State of Washington
DEPARTMENT OF FISH AND WILDLIFE

January 31, 2023

Subject: Draft Environmental Impact State: Horse Heaven Hills Wind/Solar/Battery Storage

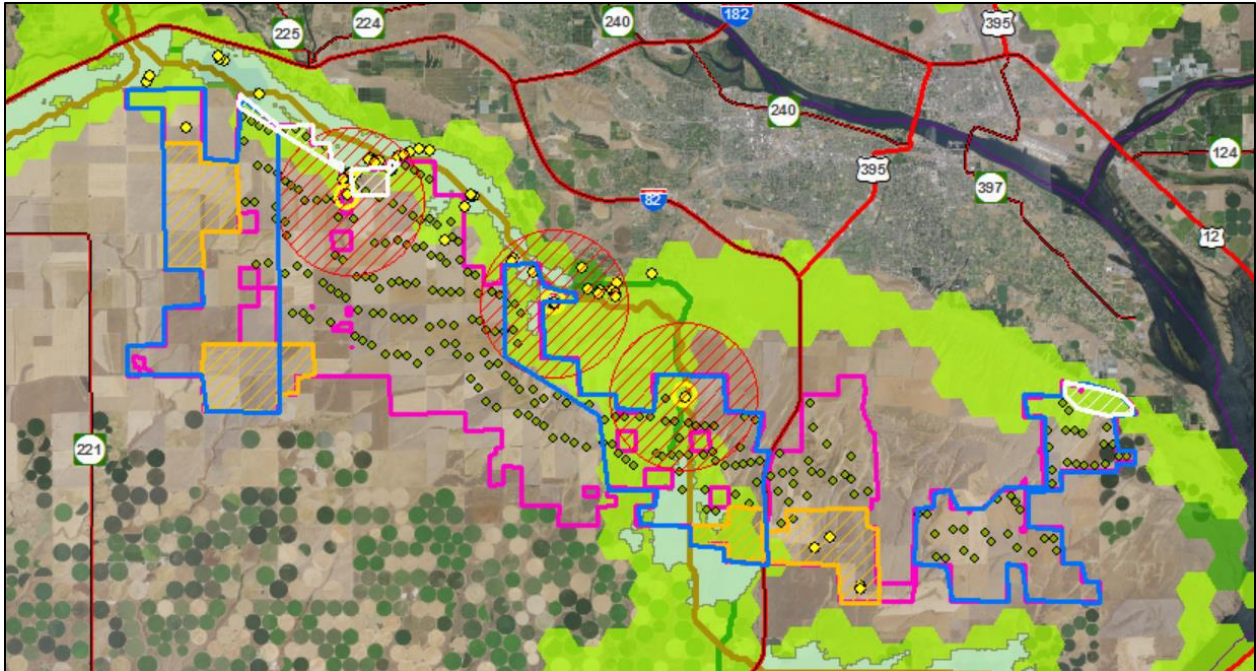
Then in February 2022, we shared with EFSEC that, “...there are 4 FEHA core area exclusion zones -from West to East - Webber, Badger, Sheep, and the eastern one, which is in the area of the Coyote Canyon FEHA nesting territory. Based on research, these core areas are where FEHA use is the highest but does not include the entire home ranges, so FEHA will still be exposed to turbines outside of these areas. Additionally, there are two turbines to the north just outside of the Webber exclusion zone that we also discussed with you that should also be excluded.” Additionally, we pointed out that two FEHA nesting territories (Beck Road and 4-mile) are both within the eastern solar development area just to the east of Highway 395.

Also in February 2022, we met with EFSEC and the applicant and provided the figure below and justification for recommending the central blue polygon as mitigation, offered ideas for project infrastructure and operations and vegetation management within the mitigation area, and identified turbine exclusion zones within the red FEHA circles
